Access Compliance Report

Public Rights-of-Way

Intersection ID: 47852	Main Street: CACTUS_VALLEY_RD	Cross Street: STONE_PORCH_RD	Location: NW
ADA ID: 41854EB5EC10	Ramp Type: BlendTrans2	Initial Pass/Fail: Fail	Overall Compliance: No
Severity Score: 8.75			
Codes/Mitigation Info/Possible Solution		Field Measurements/Component Compliance

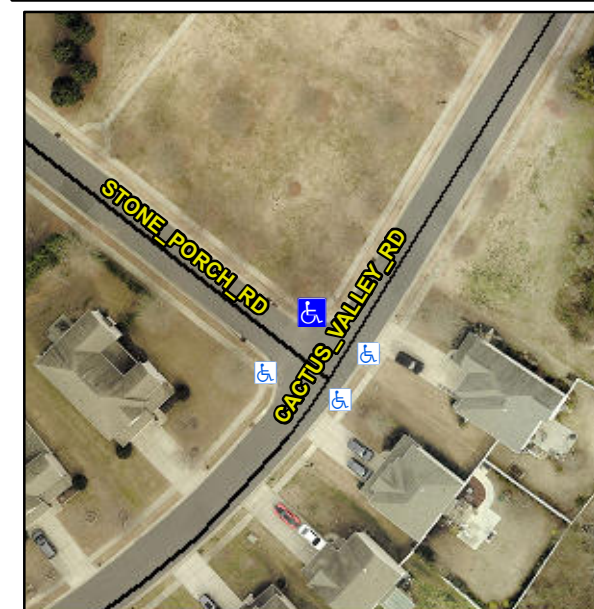
Not Found, R304.5.1

N/A	Ramp inside XWalk1?	N/A	N/A	Ramp inside XWalk2?	N/A
	Road Slope (%)	0.7		Clear Space?	N/A
	Road X Slope (%)	1.6	N/A	Clear Space to XWalk (in)	N/A
N/A	Any Obstructions?	N/A	N/A	Storm Grate/Utility Hazard?	N/A
	Obstruction Type			Storm Grate/Utility Type	
		N/A			N/A
			Yes	Surface Condition? (G/P)	Good
			No	Curb Slope (%)	22.1

Remove & Replace Curb Ramp With Two New Directional Ramps or Equivalent.
